FLORIDA POWER & LIGHT COMPANY

ST. LUCIE PLANT UNIT NO. 1

Amendment No. 63
License No. DPR-67

ATTACHMENT TO LICENSE AMENDMENT NO. 63

Figure B2.1-1 Axial Power Distribution for Thermal Margin Safety Limits

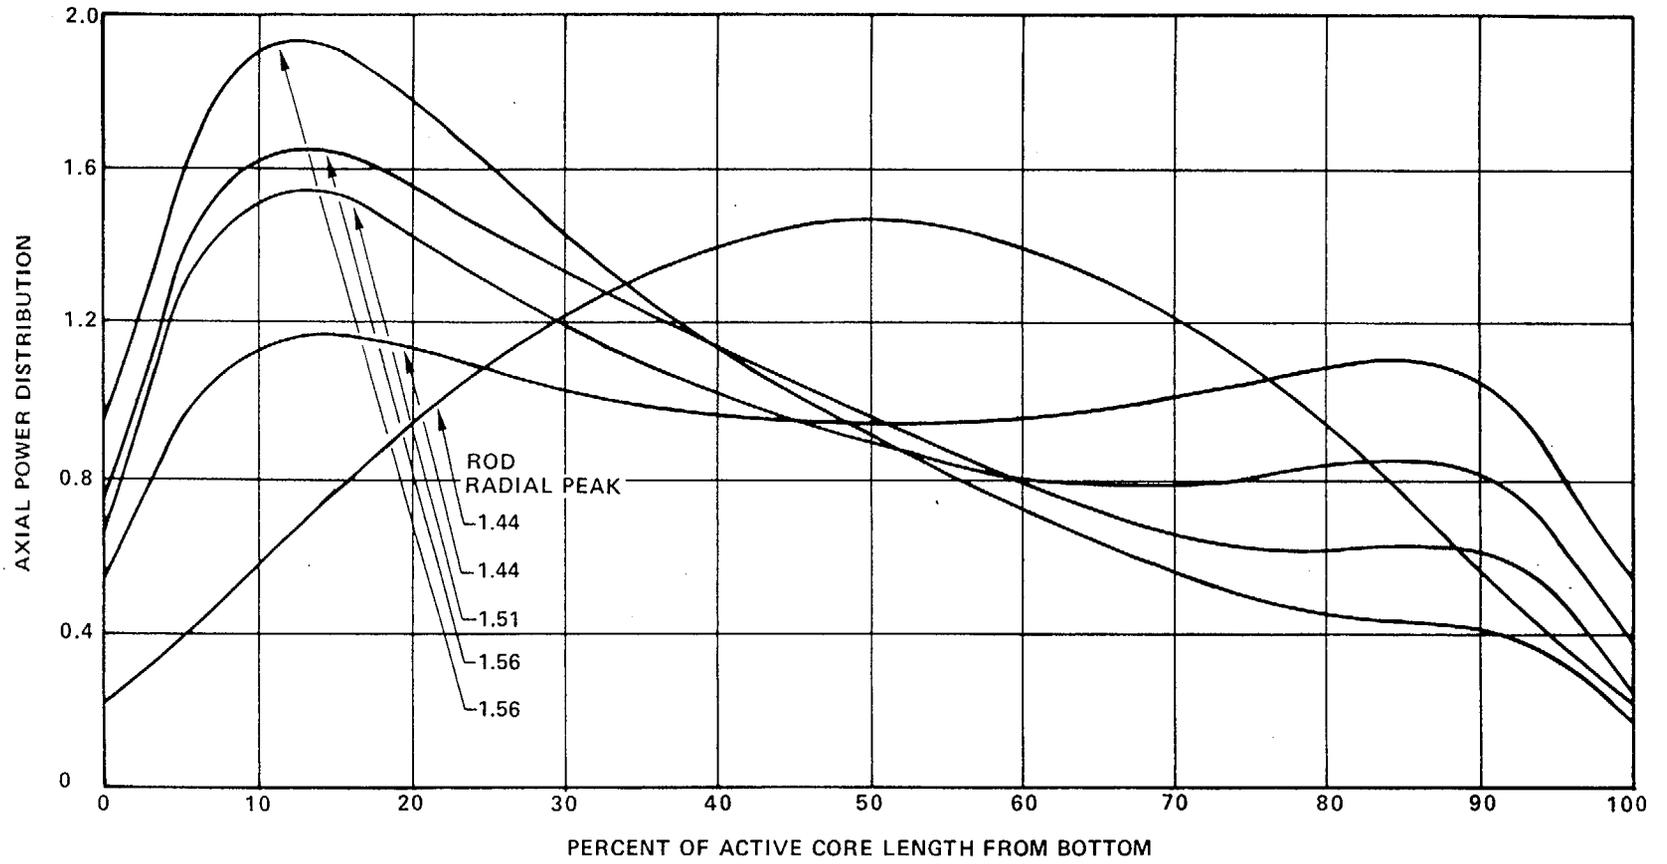
The curves of Figure 2.1-1 show the loci of points of THERMAL POWER, Reactor Coolant System pressure and maximum cold leg temperature with four Reactor Coolant Pumps operating for which the minimum DNBR is no less than the DNBR limit for the family of axial shapes and corresponding radial peaks shown in Figure B 2.1-1. The limits in Figure 2.1-1 were calculated for reactor coolant inlet temperatures less than or equal to 580°F. The dashed line at 580°F coolant inlet temperature is not a safety limit; however, operation above 580°F is not possible because of the actuation of the main steam line safety valves which limit the maximum value of reactor inlet temperature. Reactor operation at THERMAL POWER levels higher than 112% of RATED THERMAL POWER is prohibited by the high power level trip setpoint specified in Table 2.1-1. The area of safe operation is below and to the left of these lines.

The conditions for the Thermal Margin Safety Limit curves in Figure 2.1-1 to be valid are shown on the figure.
